**From:** Carpio, Karem M. <Karem.Carpio@wsscwater.com>  
**Sent:** Thursday, April 17, 2025 8:13 AM  
**To:** Andreza Danelski  
**Cc:** Aiden Ljubuncic; Bob Kyte; MDA230090.00@nf.bohlereng.com; Andreadis, Irene; Kelli DiPietro  
**Subject:** RE: SU-5454-2025 Auto Spa Express Gaithersburg

**From:** Andreza Danelski <adanelski@bohlereng.com>  
**Sent:** Tuesday, April 15, 2025 4:10 PM  
**To:** Carpio, Karem M. <Karem.Carpio@wsscwater.com>  
**Cc:** Aiden Ljubuncic <aljubuncic@bohlereng.com>; Bob Kyte <rkyte@bohlereng.com>; MDA230090.00@nf.bohlereng.com; Andreadis, Irene <Irene.Andreadis@wsscwater.com>; Kelli DiPietro <kdipietro@bohlereng.com>  
**Subject:** SU-5454-2025 Auto Spa Express Gaithersburg

I hope all is well. We received a comment from the City of Gaithersburg on the Schematic Development Plan— They're requesting an approval letter from WSSC to allow us to propose shrubs within WSSC's Sanitary Easement

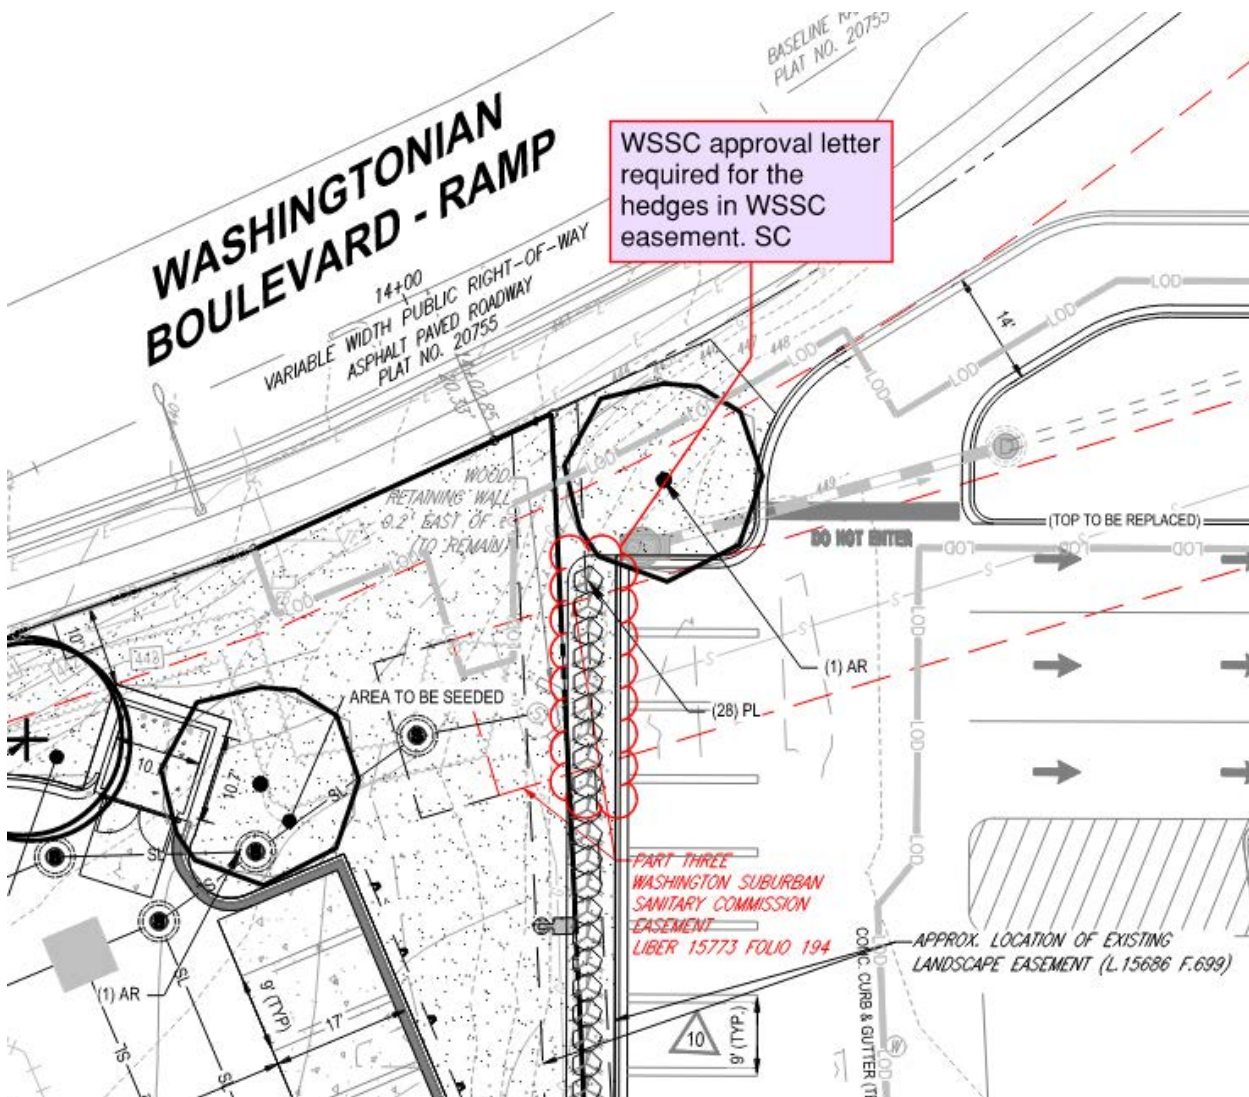
(below for your reference). These shrubs are necessary to meet the parking screening requirement. Would you be able to assist us with this request?

Proposed Shrubs are:

- Botanical Name: Prunus Laurocerasus
- Common Name: Common Cherry Laurel
- Size: 24-30" HT. & SPRD

You must provide the landscaping plans for the project where shows that is not any placement of trees within the WSSC easement, and a minimum clearance of 10' between any trees and the WSSC Vaults, MHs, water and sewer mains (WSSC PDM Part One, Section 25.d.7). The approval letter that is referring is the SU Permit Letter approval.
